UNITED STATES PATENT AND TRADEMARK OFFICE

APPLICATION NO.	FILING DATE	FIRST NAMED INVENTOR	ATTORNEY DOCKET NO.	CONFIRMATION NO.
10/680,269	10/07/2003	Tyler J. Dembicks	6053-94	6354
30448	7590	07/11/2005	EXAMINER	
AKERMAN SENTERFITT P.O. BOX 3188 WEST PALM BEACH, FL 33402-3188			SANDY, ROBERT JOHN	
			ART UNIT	PAPER NUMBER
			3677

Office Action Summary

DETAILED ACTION

FIG. 6

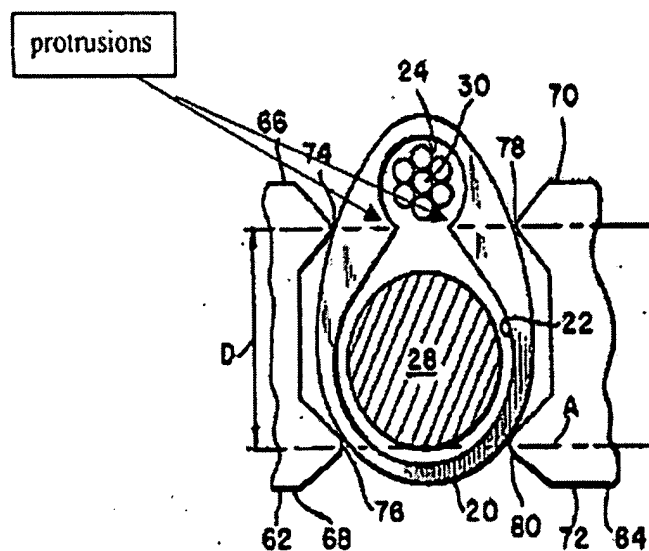
Claims 1-3, 5, 12, 15, 16, 18, 25, 27-29, 33, and 34, are rejected under 35 U.S.C. 102(b) as being anticipated by Luongo (U. S. Patent No. 3,916,517). Luongo ('517) discloses a crimp (see Fig. 1-7, Fig. 6 provided herein), comprising: a body (20)

having at least one fishing line receiving cavity (24, 96, is capable of being a fishing line receiving cavity) extending through the body and adapted to receive at least two diameters of a fishing line; and at least one pin cavity (22, 94 is capable of receiving a pin) adapted to receive at least one pin (28), the at least one pin (28) extending from the body;

(concerning claims 2, 15, 27 and 28) the at least one line cavity extending through the body is formed from two opposing sidewalls (48, 50, or sidewall portions having crimp detents 94, 96) shaped to receive two diameters of a fishing line having a substantially cylindrical cross-section;

(concerning claims 3, 16 and 29) each of the two opposing sidewalls comprise at least one protrusion (see Fig. 6 above) for positioning a generally cylindrical fishing line in the at least one fishing line receiving cavity;
